STEEL BACKPLATE - OD 82 mm

Dimensioned reference | Dimensions in mm | Print at 100% / Actual size

GEOMETRY AND REVISION - 19 OCTOBER 2026

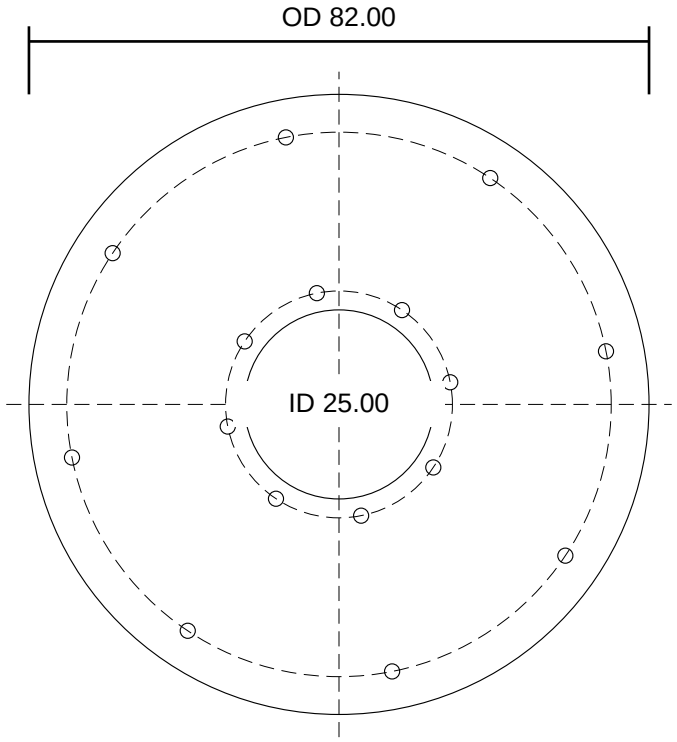
Revision: OD 80 to 82; centre opening and bolt pattern retained.

Diameter 2.00 retains the existing template; confirm final fastener clearance.

Confirm clearance to PCB nuts, washers and rotor runout in the assembled motor.

Outer diameter 82.00; central opening diameter 25.00.

16 bolt-hole circles, diameter 2.00: 8 on PCD 72.00 and 8 on PCD 30.00.

Each ring: 45 degrees apart; first centre 11.25 degrees counterclockwise from right axis.

Steel thickness 2.00; no rectangular magnet cut-outs.
